From: Kevin Bown <Kevin.Bown@nationalhighways.co.uk>
Sent: 25 March 2025 18:42:11 UTC+01:00
To: "eve.hearsey@adur-worthing.gov.uk" <eve.hearsey@adur-worthing.gov.uk>
Cc: "Planning SE" <planningse@nationalhighways.co.uk>
Subject: National Highways response re AW Case Officer query AW Ref: AWDM/0354/23
NH Ref: NH/23/01185 #24784 : 79 Upper Brighton Road, Sompting, BN15 0JN

From: Eve Hearsey <eve.hearsey@adur-worthing.gov.uk>
Sent: 20 March 2025 11:36
To: Planning SE <planningse@nationalhighways.co.uk>
Subject: #24784 Our Ref: AWDM/0354/23 Your Ref: NH/23/01185 : 79 Upper Brighton Road, Sompting, BN15 0JN

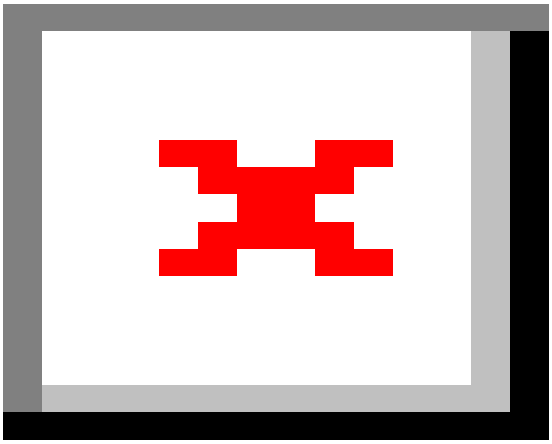
I have a couple of queries relating to your correspondence and the planning application. The attached plan is not dated October 2024 but November 2024. Is this the plan that you require to be the approved plan?

My other query is that whilst there may not be a front boundary wall at the property, there is a side boundary wall to no. 77 which is higher than 0.6m which thereby impedes driver visibility and there is no vehicular crossover marked on the plan.

1. The drawing reference should say ‘November 2024’ (as you note) and not ‘October 2024’ as contained in Elizabeth’s cover email and the NHPR. The October 2024 version was the first one we reviewed, and November 2024 is the final version, with the visibility splay revised to meet DMRB requirements.

2. With regard to the height of the wall at the adjacent property (no. 77 Upper Brighton Road), this is not a concern as the visibility splay is located in the area between the wall and the carriageway e.g. it does not go over the wall of no. 77. This can be seen on the drawing below.

3. The proposed vehicular crossover is shown on the drawing, with a width of 5m, as shown below.
